APPLICATION NO.	FILING DATE	FIRST NAMED INVENTOR	ATTORNEY DOCKET NO.	CONFIRMATION NO.
09/703,282	10/31/2000	Vadim Gektin	Sun-P5363	2267

Office Action Summary

DETAILED ACTION

Figure A: The modified figure corresponds to figure 2 with some limitation shown.

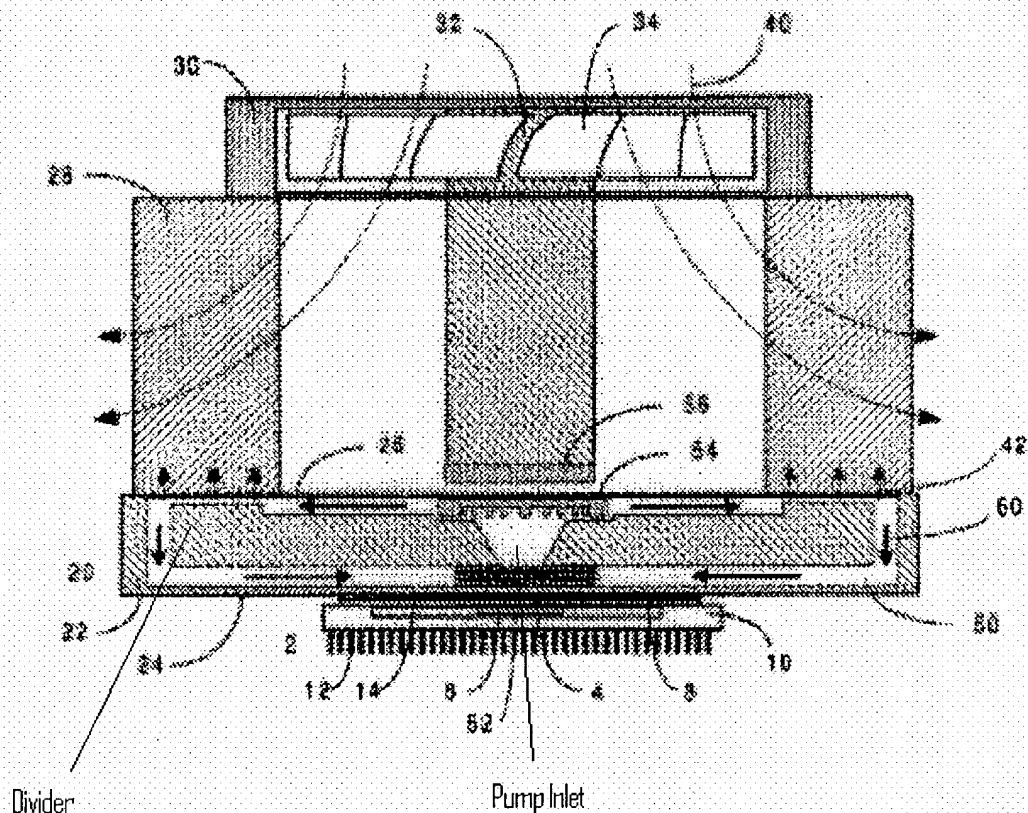
Claims 1,2,4-5 and 8-17 are rejected under 35 U.S.C. 103(a) as being unpatentable over Batchelder (US 6,019,165) in view of Batchelder (US 6,175,495) and Dodson (US 5,787,971). Batchelder discloses (figures 2,7,8 and Figure A as bellow) a liquid heat sink comprising an aluminum or copper base (20) having a first surface (24) and a second surface (26); the first surface being configured to be in contact with the heat source; a plurality of fins (28) extending from the second surface; the base including a chamber disposed between the first and second surfaces (24,26); the chamber including a divider (206) disposed with the chamber and between the first and second surfaces; a pump, which includes components such as fan (30), magnet (56) and impeller (54), approximate to an upper edge of the base (20); an inlet of the pump (as indicated in the Figure A) being proximate the first surface of the base to receive a cooling fluid such as water disposed within the chamber; an outlet pump proximate to the second surface and

configured to pump the cooling fluid over the second surface; and a fan (30) attached to the fins.

Batchelder further discloses (figures 7 and 8) that the divider (206,210) including a plurality of flow dividers (222,226,234) extending radially from the pump to maximize heat transfer from the fluid to the fins.
